City of
Richmond

Report to Development Permit Panel

Re: Application by Zhao XD Architect Ltd. for a Development Permit at 9800, 9820, 9840 and 9860 Granville Avenue

STREET ELEVATION ON GRANVILLE AVE.

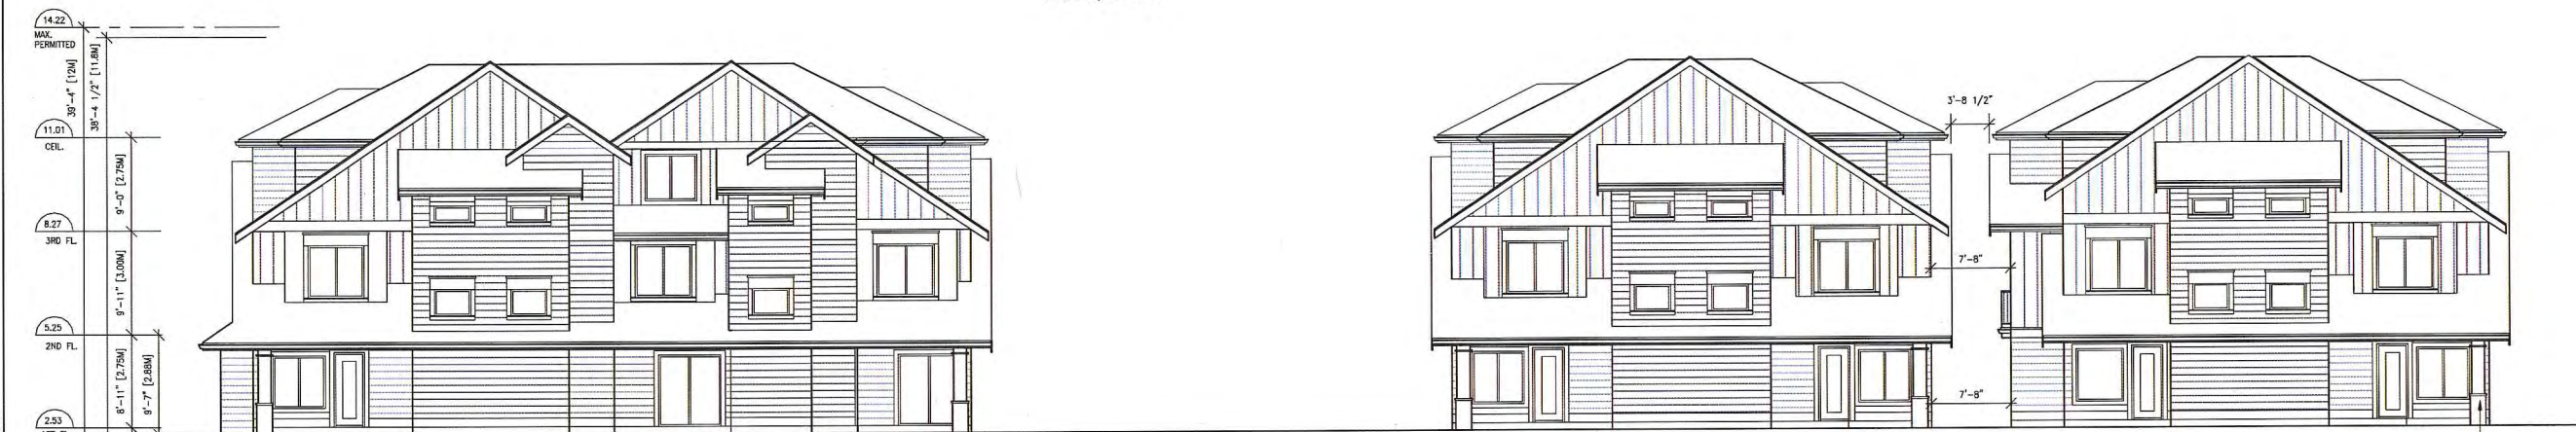
- stairs at the back units appear institutional;
Larger head trims are added to windows on staircases, which reduces the punched window effect with the extra decoration adds more residential building character (see drawing A6, A8 & A8.1).
